Product Announcement

New Drums Introduced - Steel Yellow Zinc Plated

Manaras-Opera Improves It's Drums on Multiple Applications

DRUM 006 replaces **DRUM 001**
DRUM 005 replaces **DRUM 004**

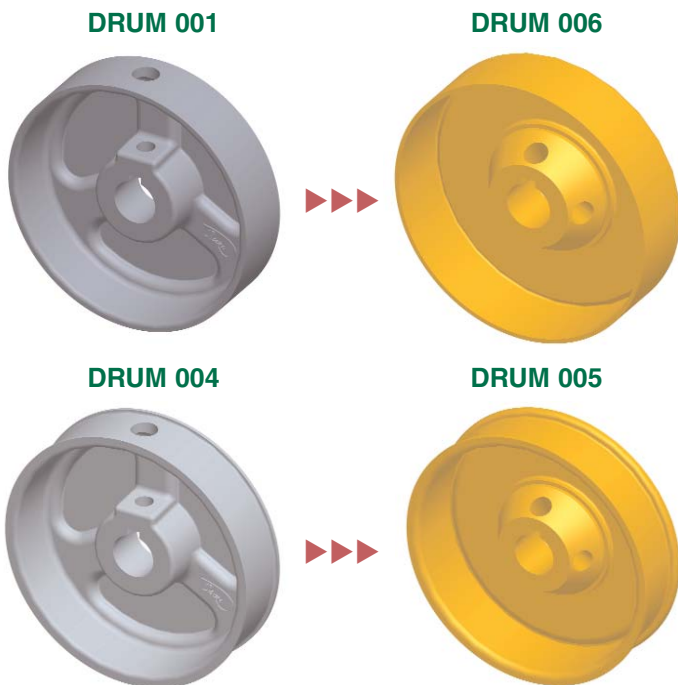
- The aluminum alloy drums have been replaced with yellow zinc plated steel drums.
- Steel yellow zinc plated drums have an increased lifetime in comparison to the aluminum alloy drums previously used.
- This also increases the lifespan of the brake bands and shoes, as well as increases the time between maintenance adjustments or component replacements.
- **DRUM 006** replaces **DRUM 001**; this improvement applies to **MTBH-APT/APE, BRAKE 014, MOD 113.**
- **DRUM 005** replaces **DRUM 004**; this improvement applies to **OSH/OGH/MGH/MGT/MTBH/MSL/MGSL, BRAKE 011/012/013, MOD 111.**
